Project: Santa Maria Office Building
Addendum Issue Date: February 24, 2026
Bid Date: March 5, 2026 at 5:00 pm
Architect of Record: ATA Architects

ADDENDUM 2

**SANTA MARIA
COMMUNITY SERVICES**

1 SECOND FLOOR CEILING PLAN
A112 3/16" = 1'-0"

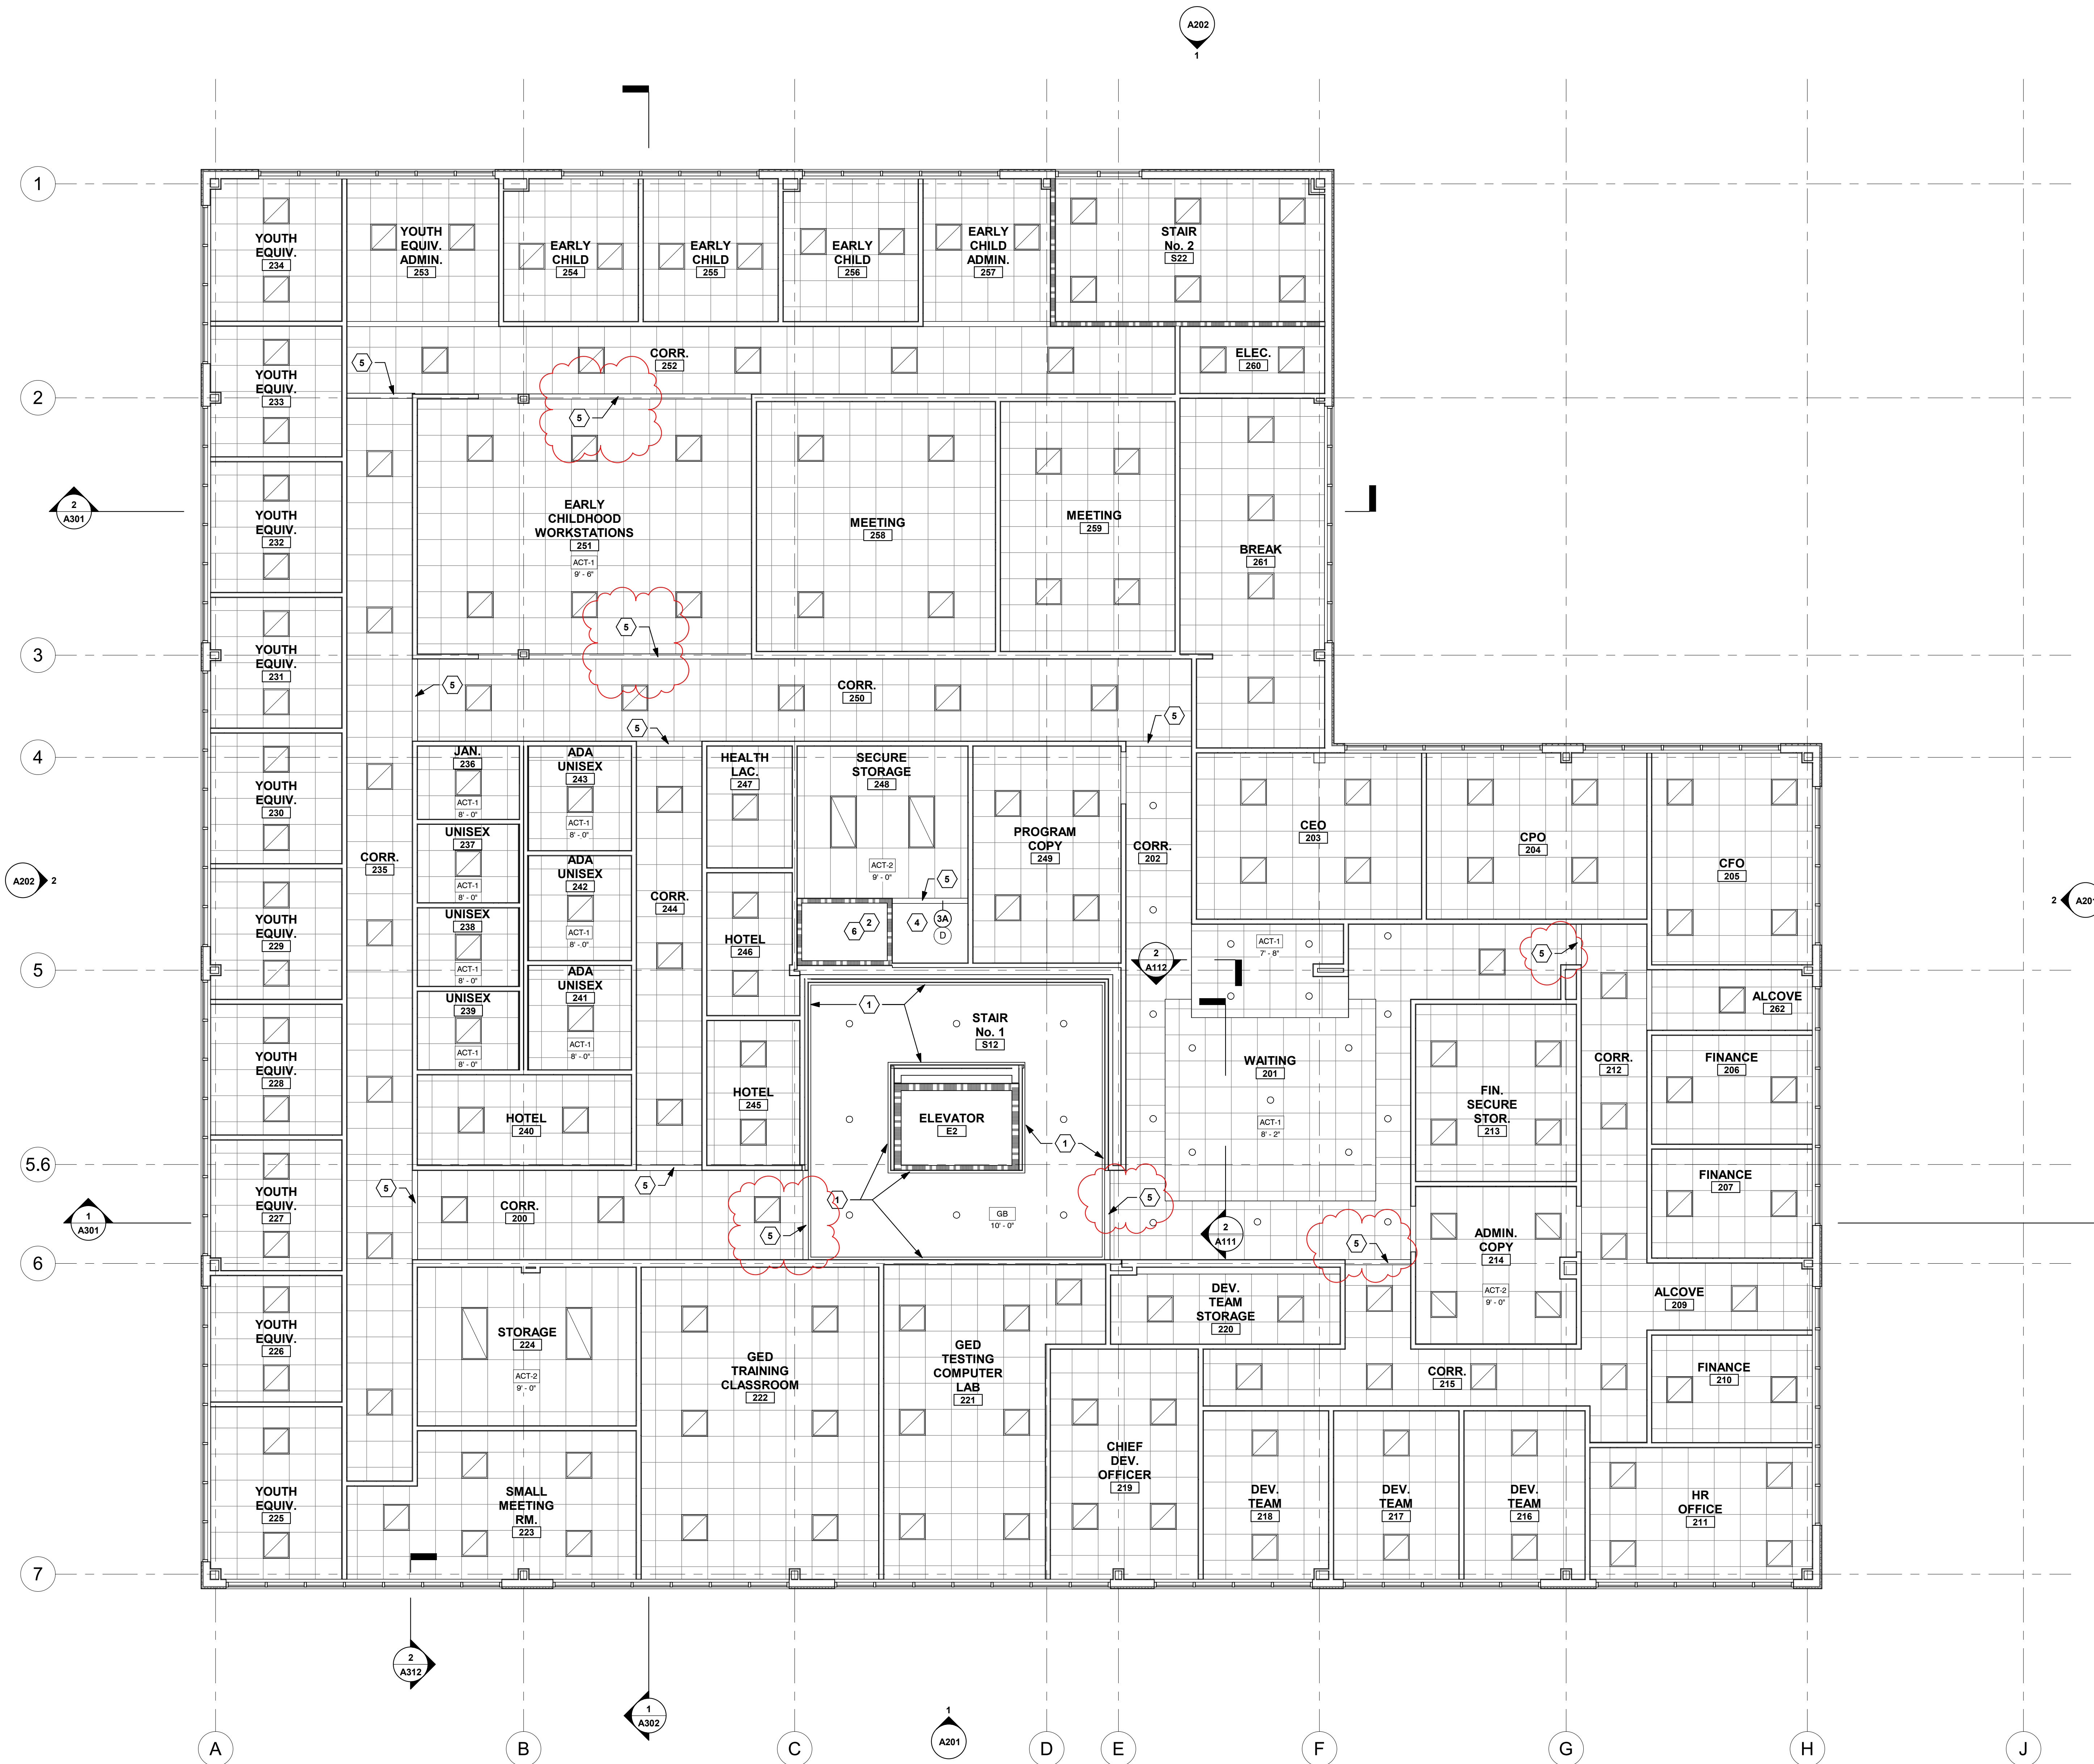
- a. Answer – Will be answered in Addendum 3.
30. The ceiling plans are missing several callouts for bulkheads (keynote 5). Please clarify on the drawings where all bulkheads are located.

- a. Answer – Bulkheads have been located on Ceiling Plans, which are reissued / attached.
31. Can you provide the finish for the mullion mates? They come in paintable, clear anodized, or powder coated.
